**Re: SWAP comments on the draft FFY 2019-2023 Transportation Improvement Program**

Re: Request for Comment on Ten Year Transportation Improvement Plan: Deferment of Boston  
- Reconstruction of Rutherford Avenue, From City Square to Sullivan Square (FY2021 and  
FY2022) (606226)

**PETITION TO LOWER MYSTIC REGIONAL WORKING GROUP &  
METROPOLITAN PLANNING ORGANIZATION  
October 2017**

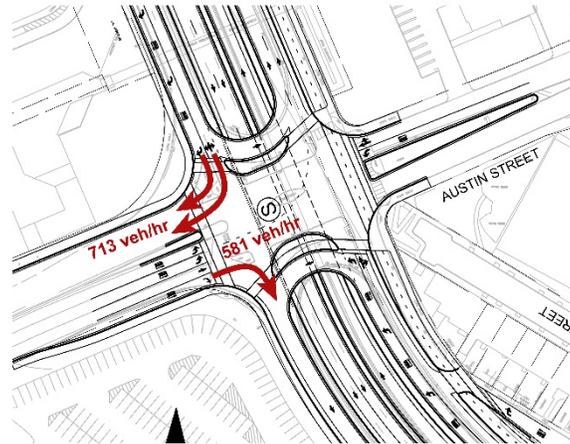
However, an analysis of the underpass option reveals exactly the opposite:

- Three of its four pedestrian crossings are unsafe – that is, they involve conflicts with right turning traffic with traffic volumes nearly triple the limit allowed by MassDOT.
- While cars that can use the underpass will fly through unimpeded, the surface streets will face delays of 2 to 2.5 minutes, with queues on the Rutherford Ave surface roads growing to almost 500 ft in both directions.
- Far from protecting the neighborhood from cut-through traffic, the underpass option will actually create serious congestion that gives traffic heading to the Gilmore Bridge an incentive to cut through the neighborhood.

### Vehicular delay for the two options

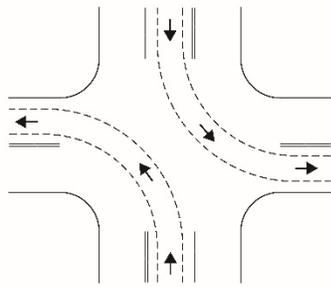
underpass option	7-lane surface option
<b>Thru traffic on Rutherford Ave</b>		
- Southbound thru average delay (s)	0	43
- Northbound thru average delay (s)	0	24
<b>All other movements</b>		
- Average delay (s)	74	59
- Average delay for most congested movement (s)	152	87
<b>Average delay, all traffic (s)</b>	<b>40</b>	<b>48</b>

The underpass option removes 40 percent of the traffic from the intersection, yet it performs poorly compared to a surface option. How can this be? It turns out that there are three aspects of an underpass that makes it an inherently inefficient solution.

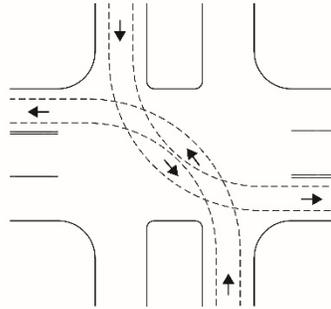
Second, ***an underpass creates a split intersection.*** The northbound and southbound surface roads will be separated from one another by about 60 ft. As a result, left turns cannot run concurrently, because they interlock, as illustrated in the figure below. The traffic signal plan is therefore forced to follow an arrangement called “split phasing,” in which each of the four legs has a turn in sequence. Split phasing is both less flexible and less efficient than the normal phase sequence in which opposite directions (e.g., northbound and southbound) run concurrently. One can observe this inefficiency at other intersections with underpasses, such as Mass Ave @ Commonwealth Ave and Mass Ave @ Huntington Ave in Boston, where traffic on the surface roads is often backed up.

Lefts at compact intersections do not conflict.

Interlocking lefts at split intersections cannot run concurrently.

# TRAFFIC ANALYSIS RESULTS - AM Peak - Tt

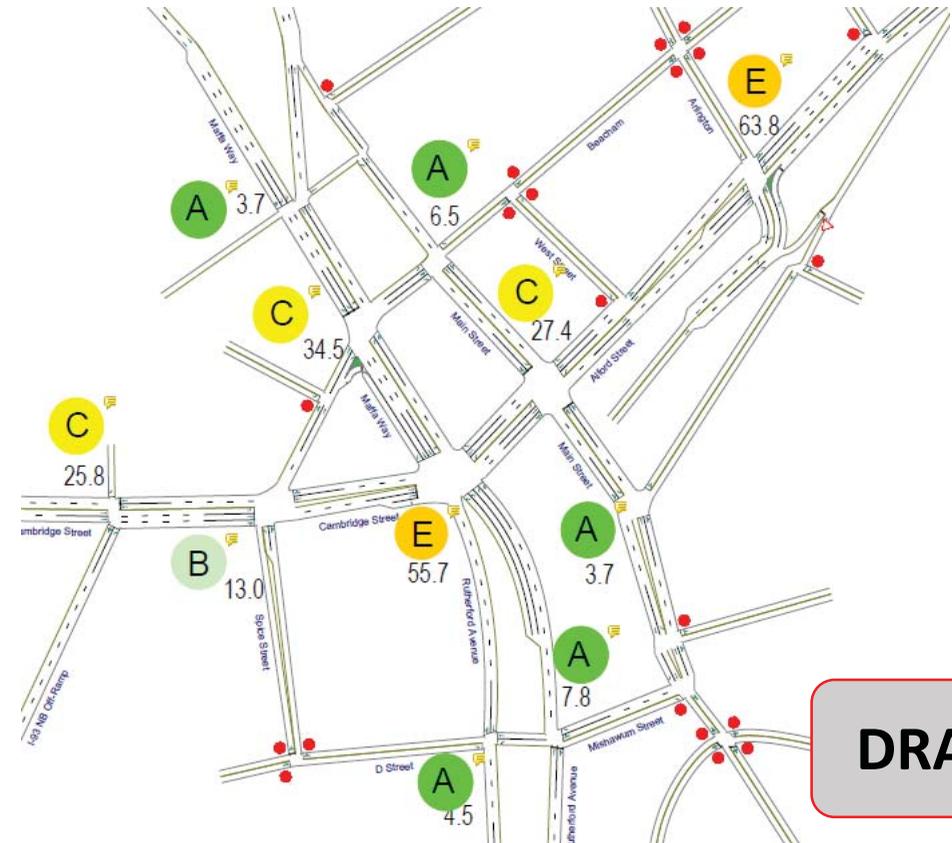
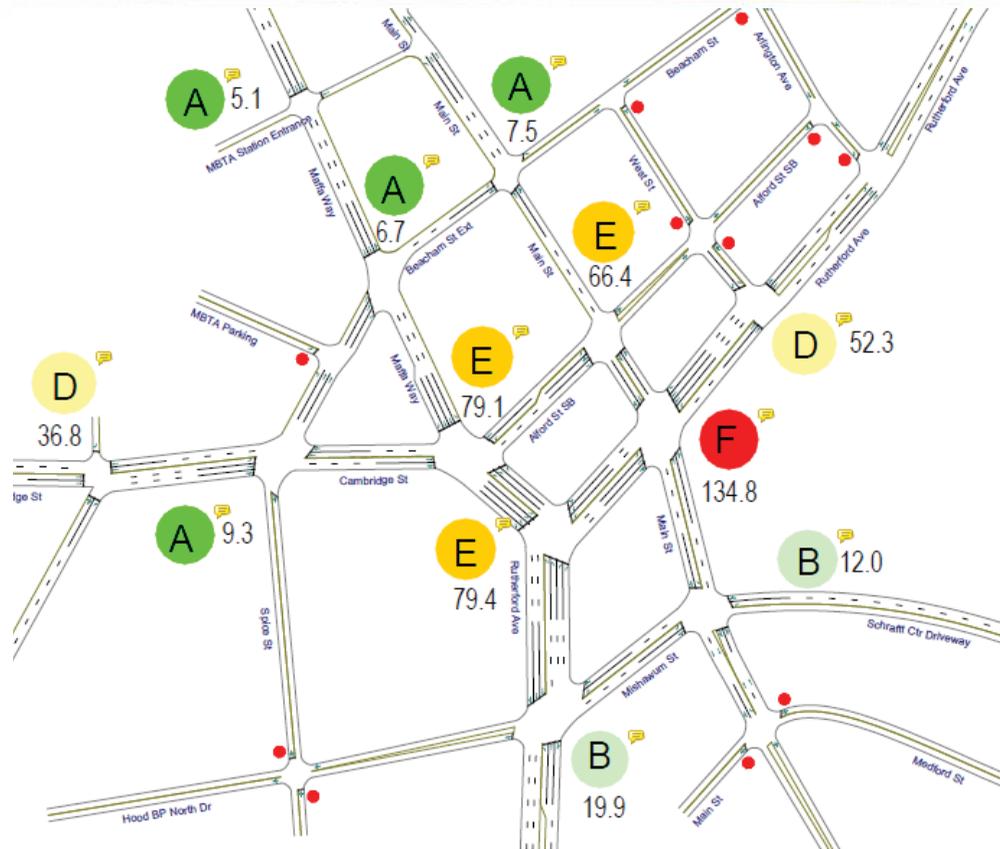
- BTD’s data indicates most intersections at Sullivan Square will be at LOS A during morning and afternoon peak traffic in its Underpass Option design, a roadway capacity inconsistent with MPO goal of capacity management, and which violates clean air/clean communities goals by encouraging an increase in driver use of the corridor.
- BTD failed to use contemporary traffic assumptions exhibited in studies of McGrath Boulevard, thus effectively estimating future demand too conservatively.
- BTD did not fully explore a Surface Option design which could provide reasonable levels of service in what is a dense urban setting. The cost of such an option remains undetermined. We believe the decision to proceed with an Underpass Option is premature and presents a substantial cost risk to the TIP.
